REGISTRY OF RADIOACTIVE SEALED SOURCES AND DEVICES
SAFETY EVALUATION OF DEVICE
(AMENDED IN ITS ENTIRETY)

NO: NR-636-D-101-G

DEVICE TYPE: Static Charge Neutralizer

ATTACHMENT 2

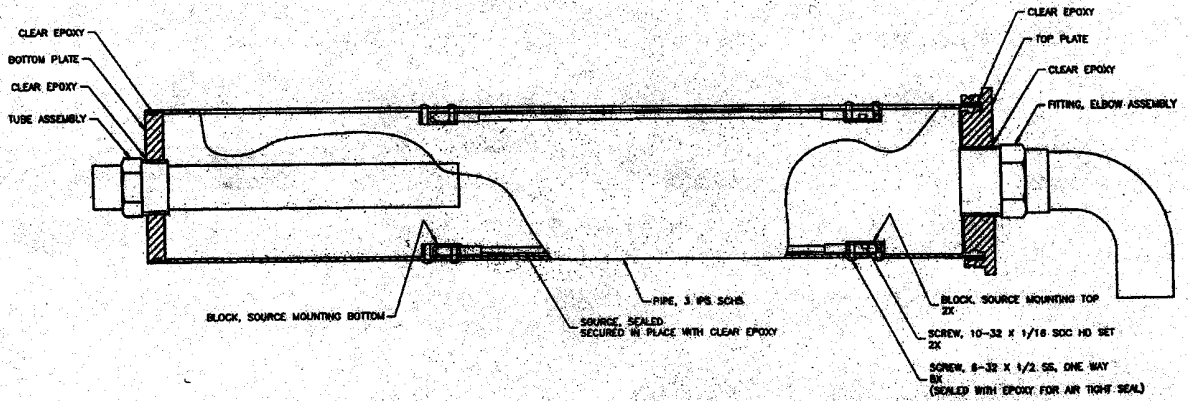
For Model 3054, fasteners (rivets) changed to stainless steel 6-32x1/2 one way screws to prevent the customer from removing the rivets and for ease of assembly.

ATTACHMENT 3

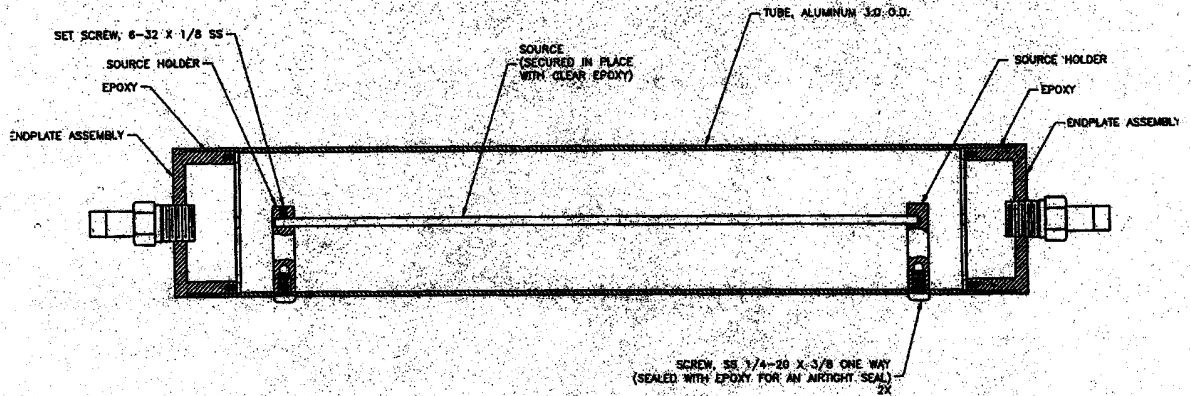
For Model 3012, fasteners (Phillips head screws) changed to stainless steel 1/4-20x3/8 one way screws to prevent the customer from removing the screws.
